Attachment 2

Mark-ups for the Associated COLA Revisions for 2.5.2 RAIs

Mark-up for FPL Revised Response
to NRC RAI No. 02.05.02-2 (eRAI 5896)

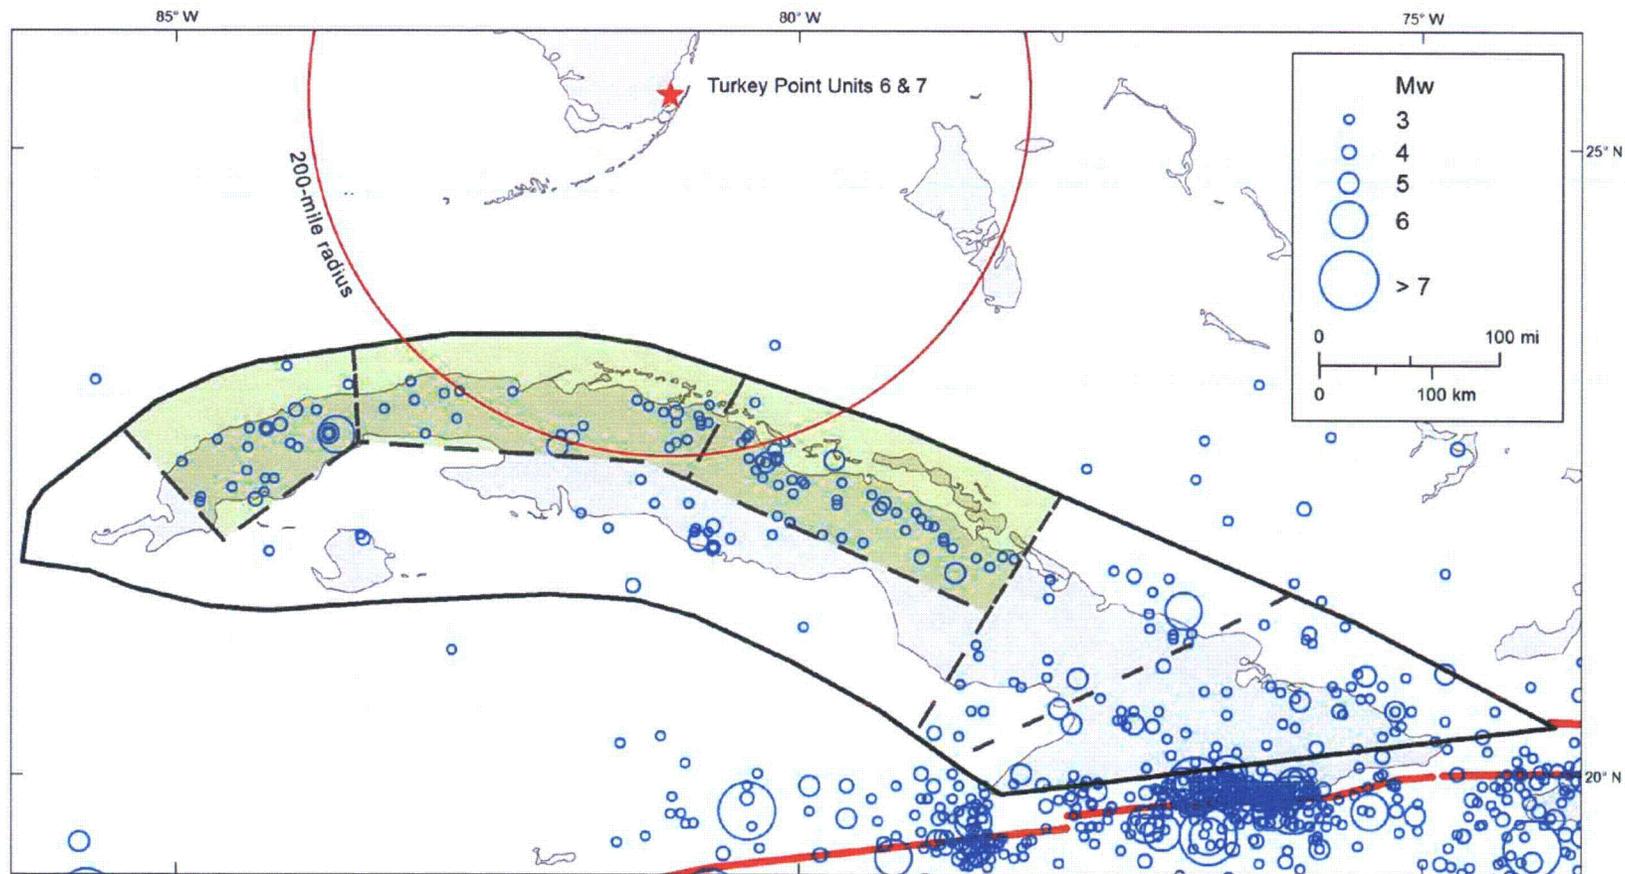
- **Six areal source zones scenario (Z6)**: In the six areal source zones scenario, Cuba is divided into six zones largely on the basis of observed patterns in seismicity (Figure 2.5.2-271). The seismicity *b*-value is constant across all six zones and equivalent to that used in the Z1 scenario; the seismicity *a*-values vary from zone to zone, are uniform within each zone, and are based on the observed seismicity within each zone. For the six-zone scenario (Z6), the *a*-values were determined by counting the number of events in each subzone greater than or equal to M_w 3.0. The *b*-value in base case Z1 is used for all six subzones. The Z6 scenario results in the lowest contribution to hazard from the three zone scenarios (Table 2.5.2-233).

Figure 2.5.2-272 Map of Intraplate Cuba Fault Sources for Hazard Sensitivity Calculation

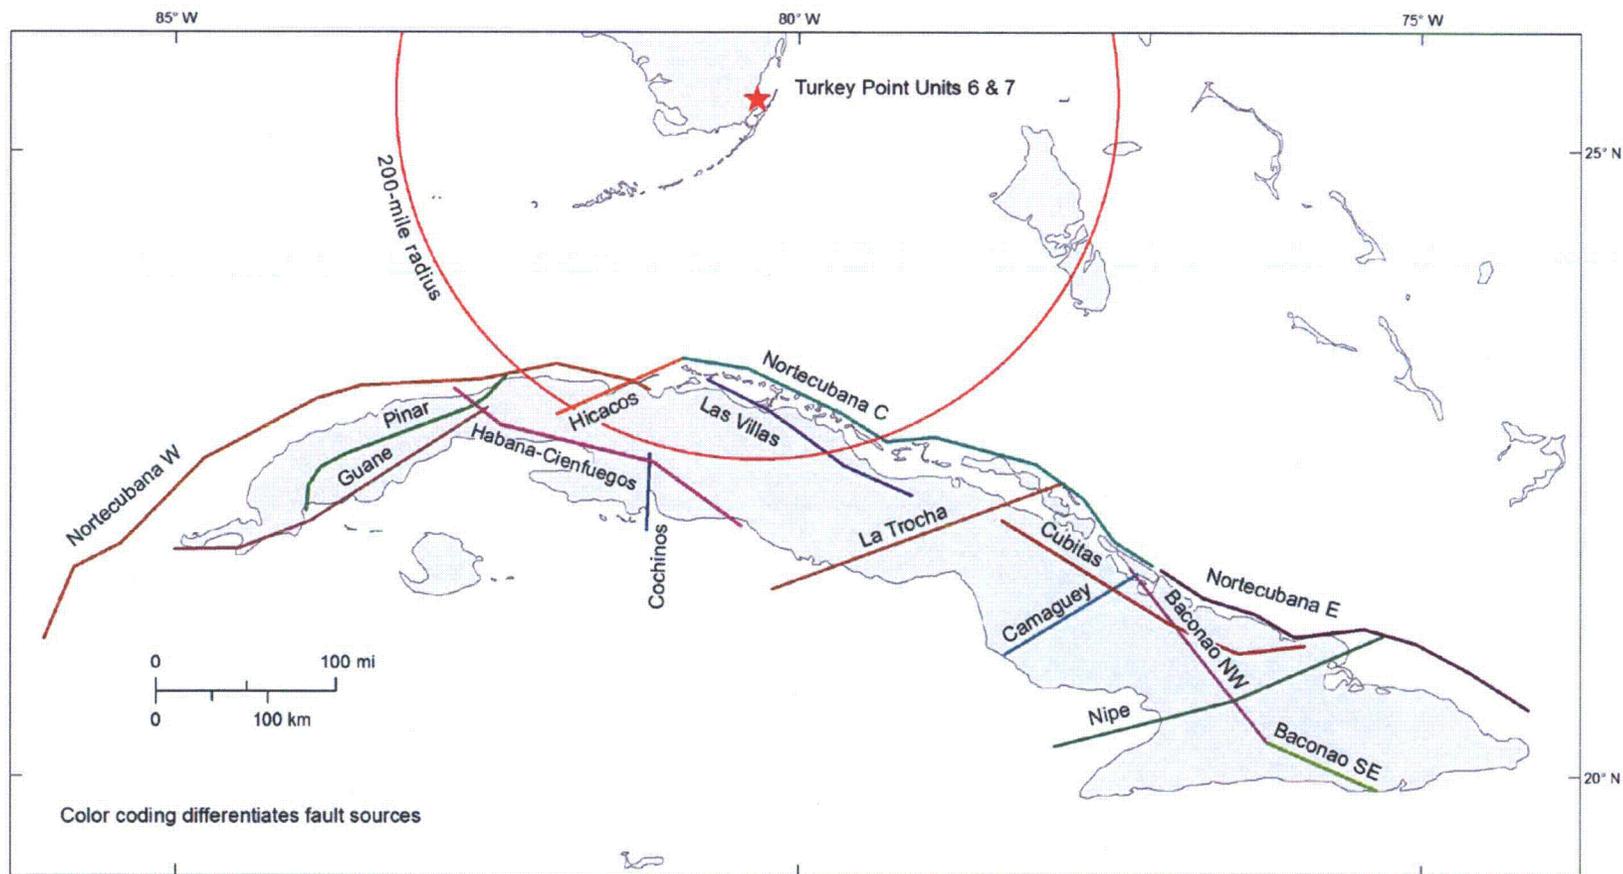
The input parameters for the Cuba sensitivity fault sources are described below and are summarized in Table 2.5.2-236 and Figure 2.5.2-272:

- **Fault sources and geometries**: Intraplate Cuba fault sources include Cotilla-Rodriguez et al.’s (Reference 321) seismoactive faults in Cuba, plus the Pinar fault (Figure 2.5.2-272). For the purpose of the hazard sensitivity calculation, it is assumed that all of these faults are capable tectonic sources. The Nortecubana fault is divided into three sensitivity fault sources, the Nortecubana West, Nortecubana Central, and Nortecubana East fault sources. The Baconao fault is divided into two sensitivity fault sources, the Baconao Northwest and the Baconao Southeast fault sources. Seismogenic depth for all fault sources in the hazard sensitivity calculation extends from 0 - 15 km kilometers (0-9 miles). All fault sources are modeled with vertical dip angle, except the three Nortecubana fault sources, all of which are modeled as dipping 30 degrees to the south.

Figure 2.5.2-273 1 Hz Mean Hazard Curves Showing Sensitivity to Cuba Source Scenarios. Lower Panel is Expanded View of Yellow Box in Upper Panel

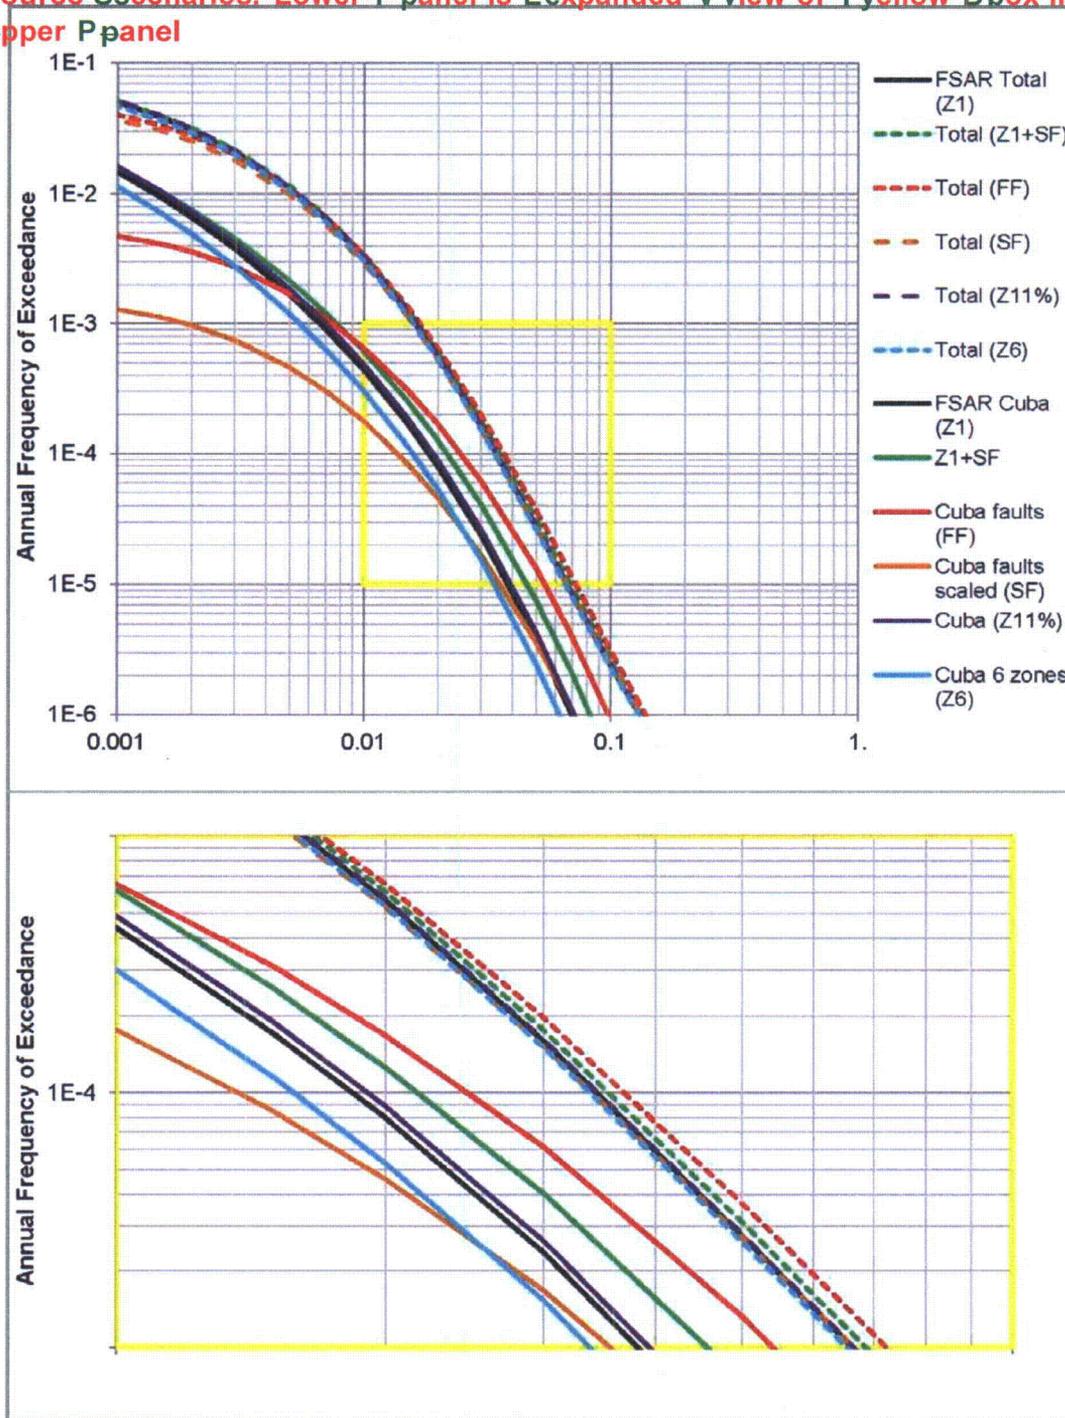
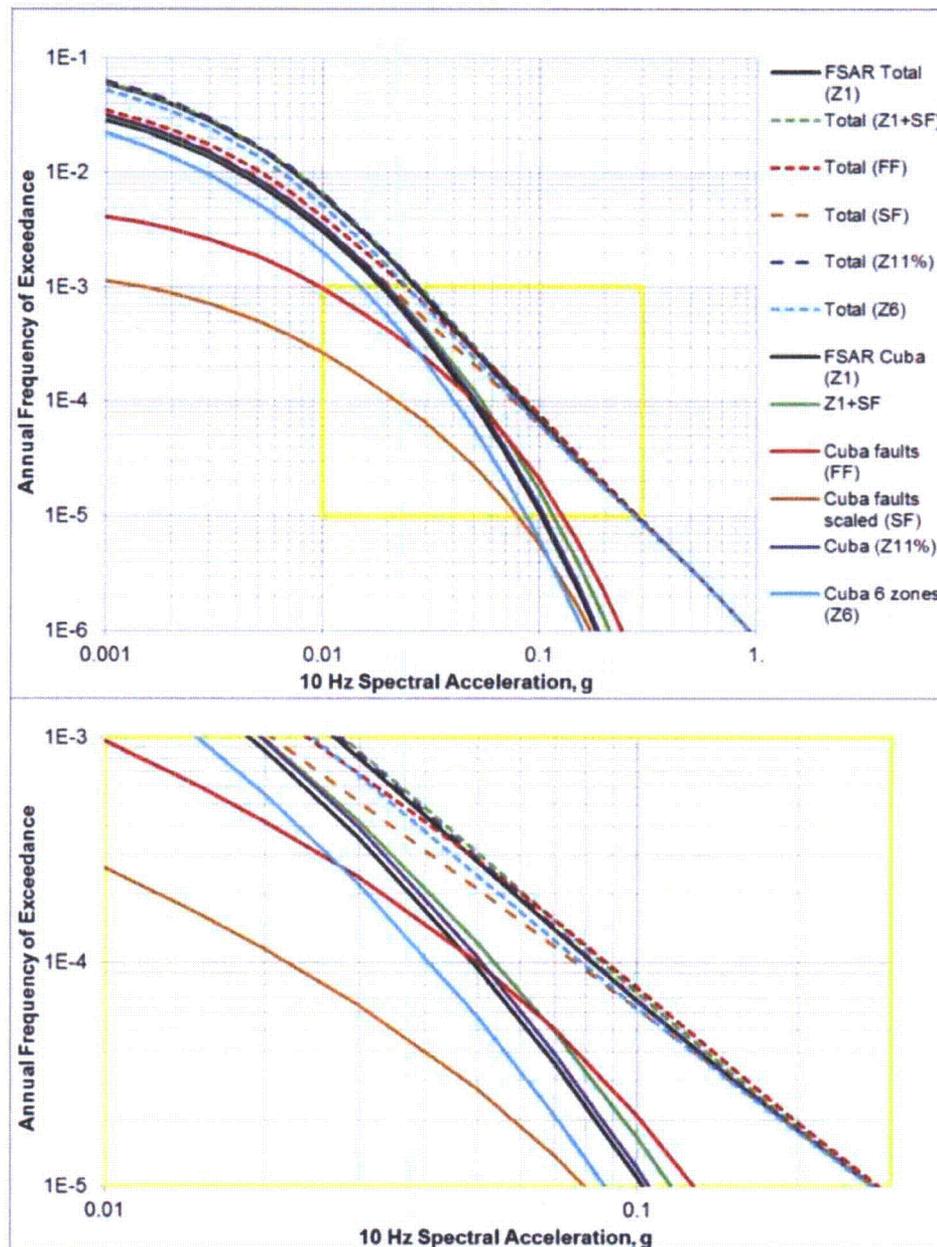
~~In order to~~To assess the impact of various Cuba sensitivity scenarios on the Turkey Point Units 6 & 7 site hazard, based on the evaluation of the hazard results presented in Figures 2.5.2-273 and 2.5.2-274, four sensitivity scenarios (Z6, Z11%, SF, and Z1+SF) were selected to represent the Cuba hazard in lieu of the Z1 base case scenario used for the original base case hazard total. Total hazard curves that include these four scenarios are presented in Figure 2.5.2-275, along with the original total hazard.

Figure 2.5.2-275 Total Mean Hazard Curves for 1 Hz (Upper) and 10 Hz (Lower) Showing Sensitivity to Four Cuba Source Scenarios

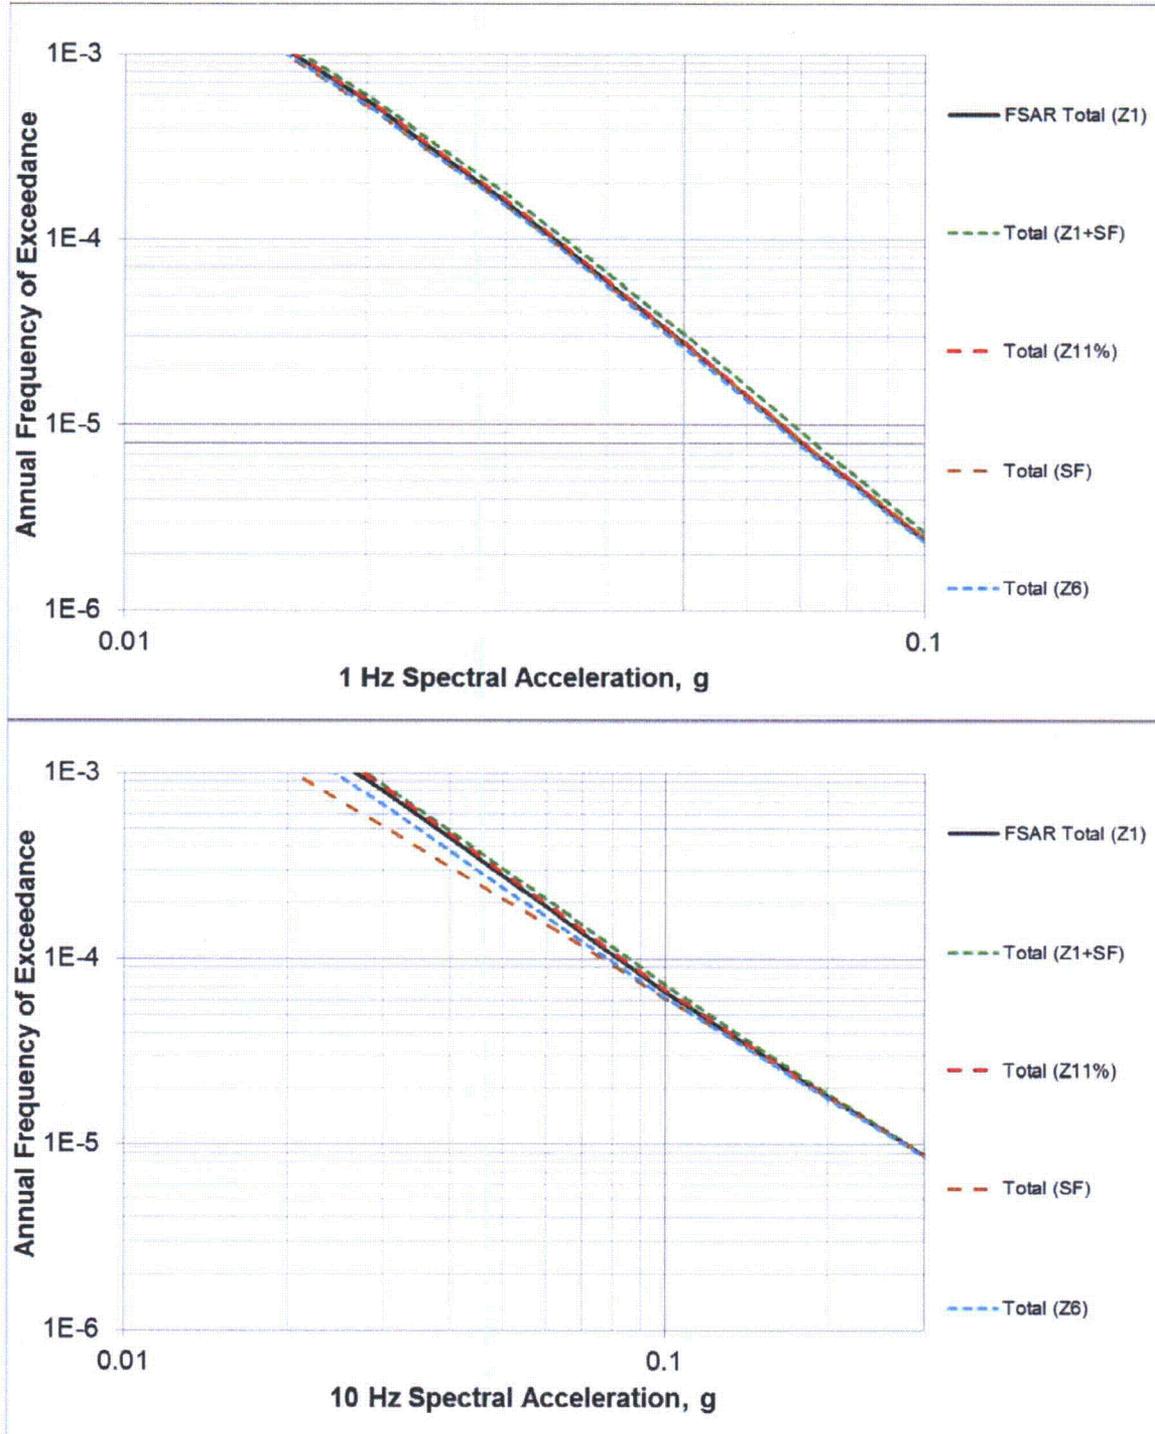
The scenarios presented in Figure 2.5.2-275 are derived from a reasonable range of technically defensible seismic source characterizations for intraplate Cuba. As shown in Table 2.5.2-239, this range of seismic source characterizations results in only small changes in hazard at the Turkey Point Units 6 & 7 site. Based on the results of these hazard sensitivity calculations, it is concluded that the use of a single areal source zone and the parameters used to characterize it as presented in Subsection 2.5.2.4.6 gives a reasonably conservative estimate of the contribution to site hazard from intraplate Cuba seismic sources.

Figure 2.5.2-276 USGS National Seismic Hazard Map Earthquake Sources
from the U.S. Geological Survey's 2008 National Seismic Hazard Mapping Project

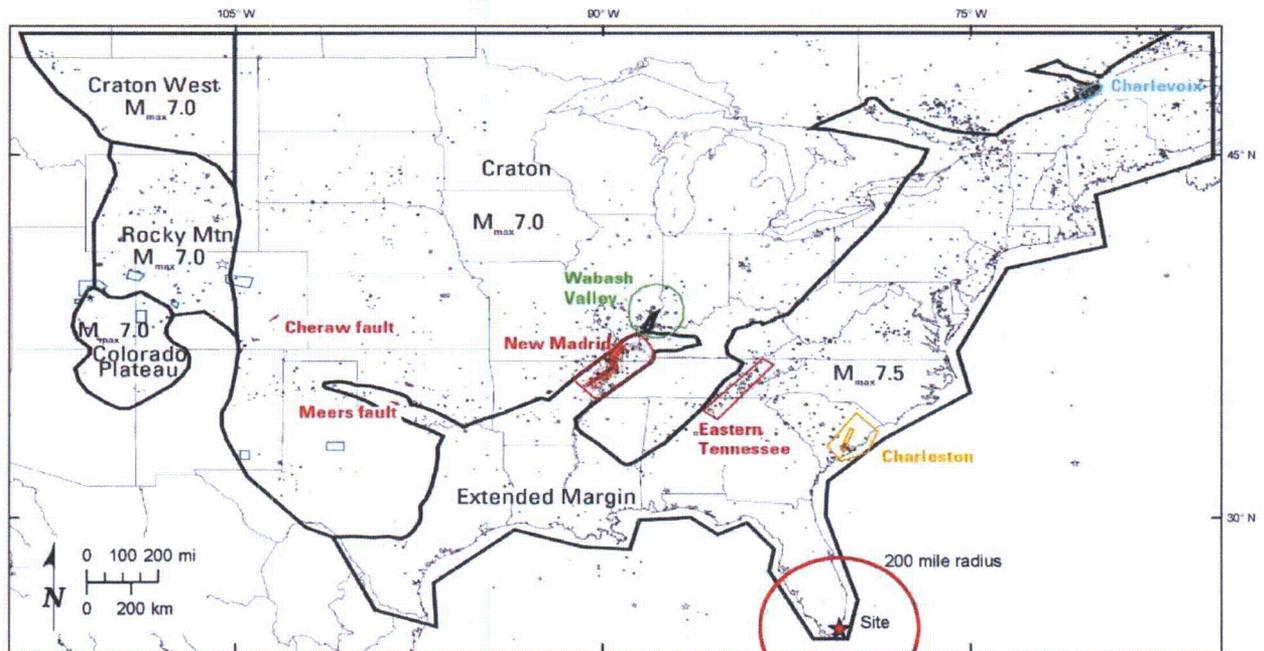
The 2008 NSHMP earthquake sources are depicted in Figure 2.5.2-~~258~~ 276. Significant changes from the 2002 NSHMP model of seismic hazard in the CEUS (Reference 251) include: (1) uncertainty in the maximum magnitude (Mmax) assigned to Mmax zones (e.g., ~~e~~Extended ~~m~~Margin); (2) revised geometry of the Charleston seismic source zones; and (3) revised magnitudes, rates, and geometry for the New Madrid seismic source. As a result of these updates, the 2008 NSHMP characterizes Mmax for the Extended Margin and Craton as weighted distributions ranging between M7.1 - 7.7 and M6.6 - 7.2, respectively. The two areal zones defining the Charleston source are both assigned Mmax distributions of M6.8 - 7.5 with a recurrence interval of 550 years, unchanged from the 2002 NSHMP. The USGS NSHMP Charleston seismic source update is discussed in ~~FSAR~~ Subsections 2.5.2.4.4.2.2 and 2.5.2.4.4.2.3.

Figure 2.5.3-205. Potential Quaternary Tectonic Structures within the Site Region

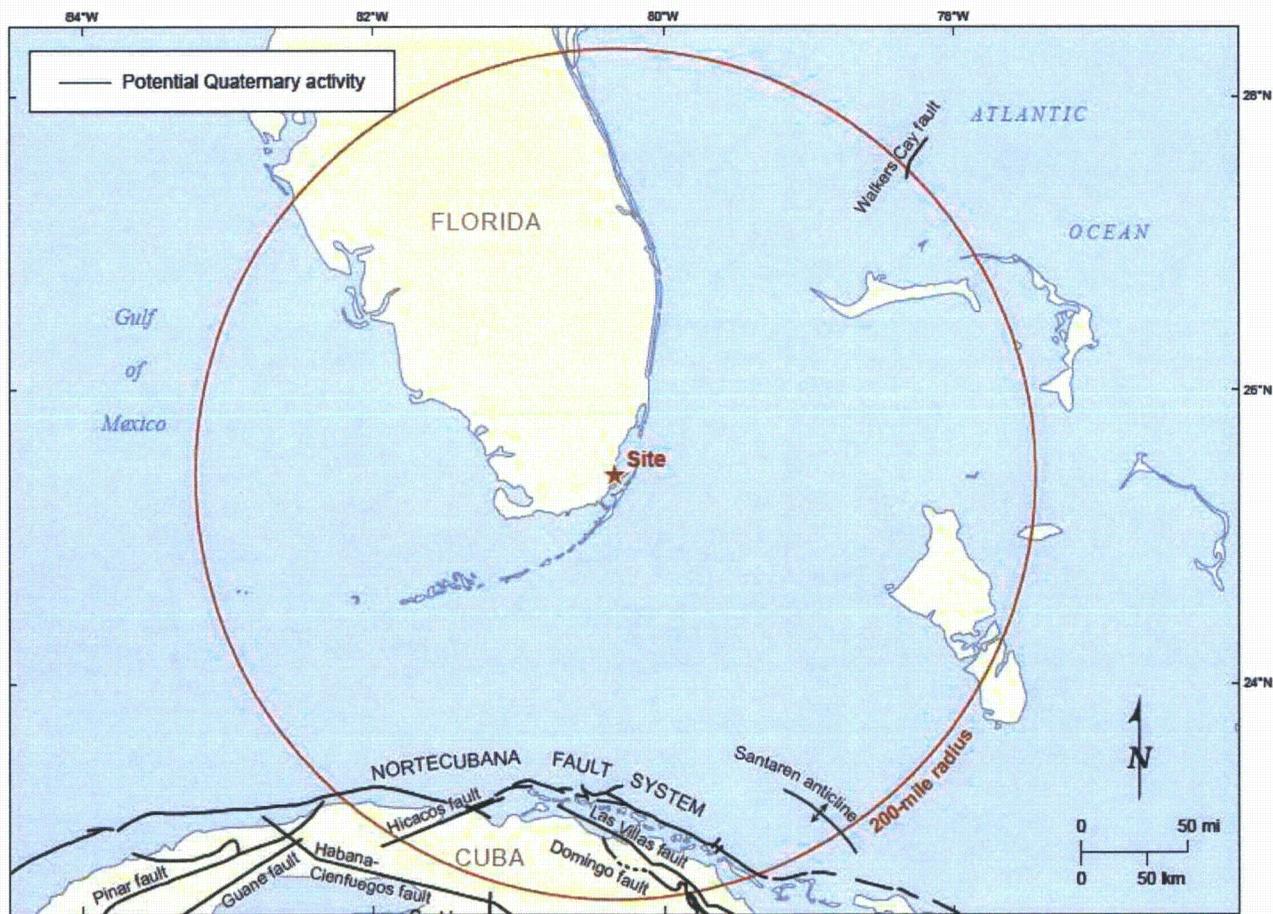
FSAR Figure 2.5.3-205 "Potential Quaternary Tectonic Structures in the Site Region" will be added to Subsection 2.5.3 in a future COLA revision as indicated below:
